API REVIEW

API's Review of Recent USGS Pavillion, Wyoming Reports Show USGS Groundwater Sampling Results Differ From EPA's Results in 2011 Draft Report

Figure 1. Modified after USGS Figure 2, Data Series 718 Report [1]

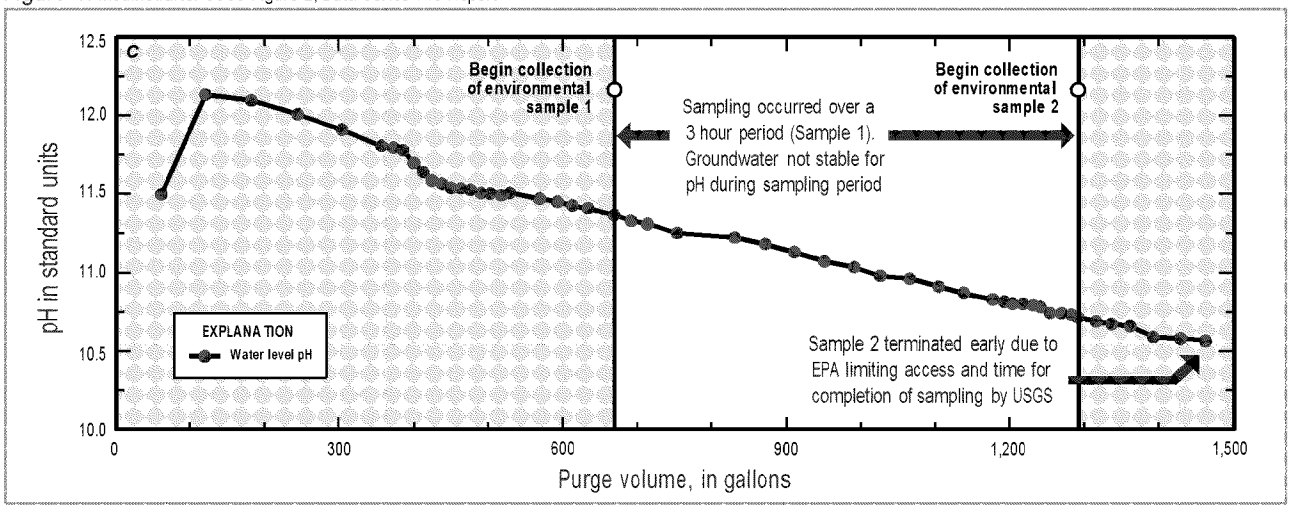
- USGS' SAP[2] specified a criterion for sampling that required the pH of the groundwater to be stable for sampling. A review of the USGS data presented in the report[1] shows, as depicted in Figure 1, pH stabilization did not occur during sampling, and the graph suggests that well MW-01 is likely still being impacted by high pH cement and/or drilling fluids used during monitoring well drilling or construction.
